# ***Interactive comment on “Water-level attenuation in broad-scale assessments of exposure to coastal flooding: a sensitivity analysis” by Athanasios T. Vafeidis et al.***

Received and published: 2 April 2019

**Fig. 1.**

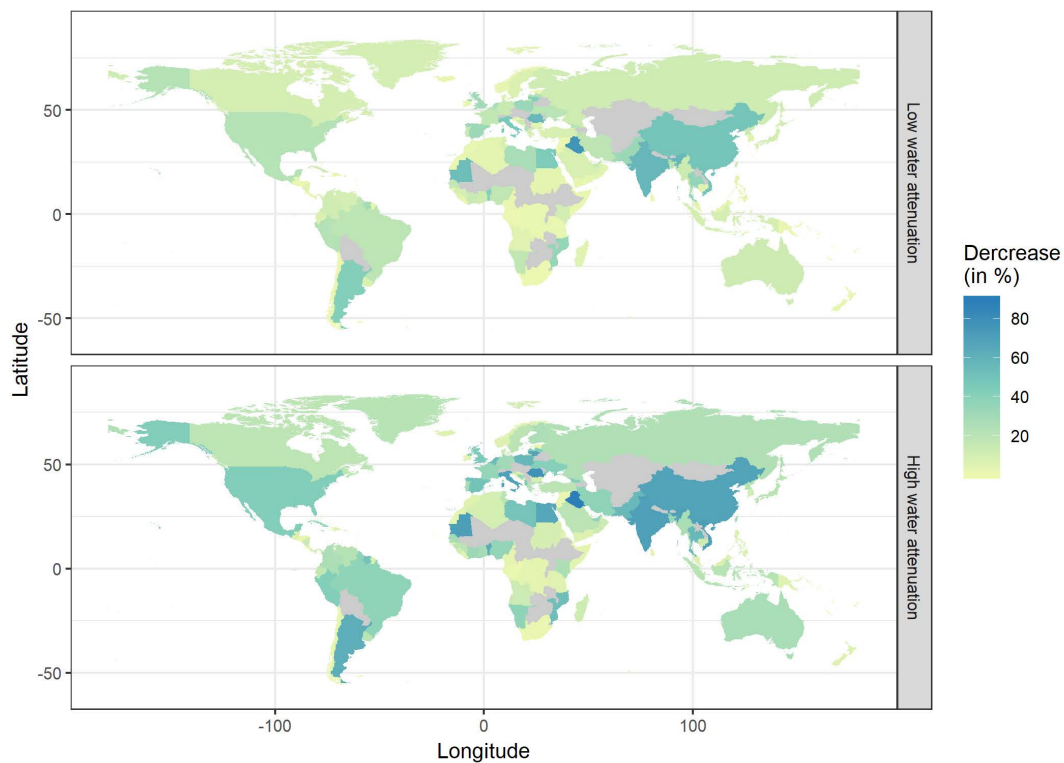
- Tab. 4 I was wondering if an additional map that shows country-by-country results (maybe only for a medium attenuation rate) would be nice to really showcase the spatial variability. The three selected countries can still be highlighted in the table.

We have followed the reviewer's suggestion and compiled a map with this information. This is now included in the manuscript as Figure 4. Further, we added some lines in the text (lines 246-249) to reflect the new figure. The map is attached and the text included now in the manuscript reads: “The reduction in impacts is not uniform across the globe and varies considerably between different countries. Some examples are given in Figure 4 and Table 4. Figure 4 shows the spatial variability of the effects of accounting for water attenuation: low water attenuation can lead to reductions in area

exposure of more than 50% and high attenuation can reduce area exposure by more than 80%.”
